August 24, 2018

ADDENDUM NUMBER 3:

Re: PD 17-18.090 Beulah Regional Park Restroom Building Resolicit

SCHEDULES & DETAILS

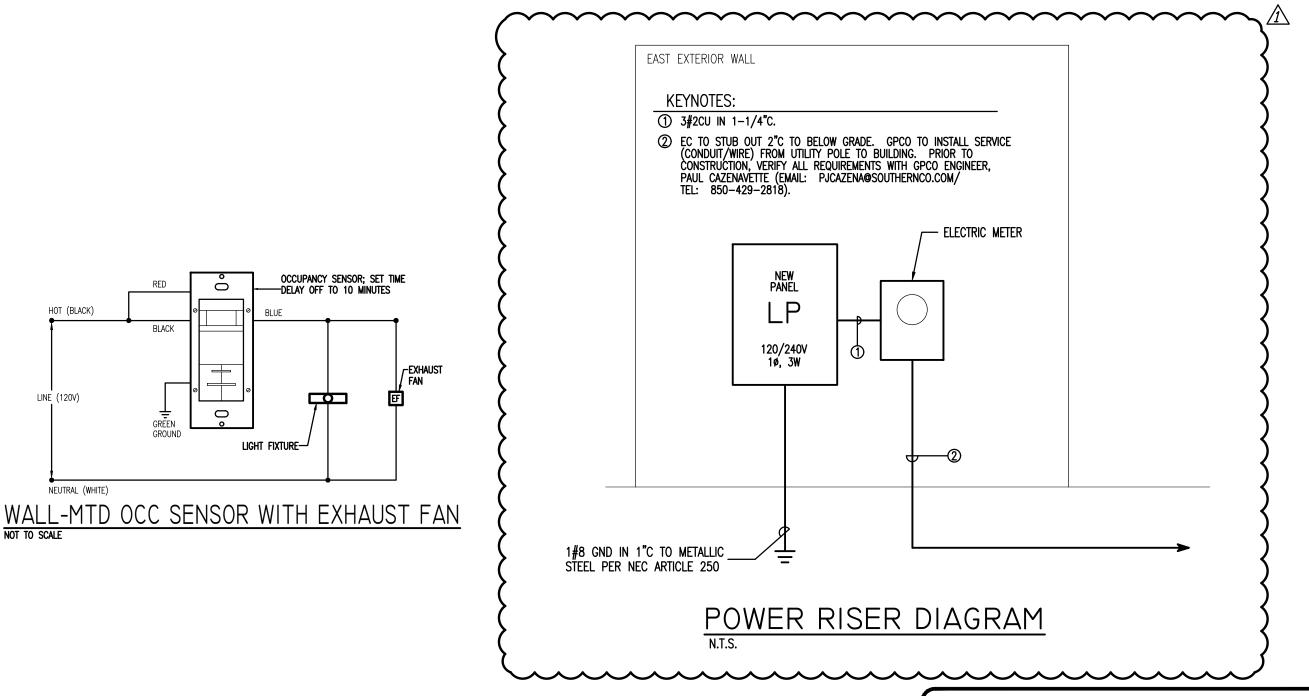
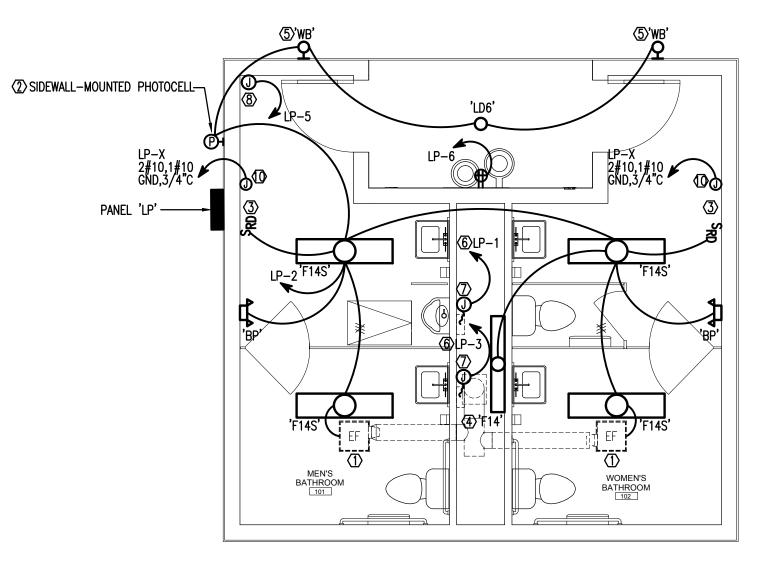
3. Below is a revised Power Riser Diagram that directs the Contractor to stub out a 2" conduit to below grade. The power company will install service from the utility pole to the building. The Contractor shall verify all requirements with the power company's engineer
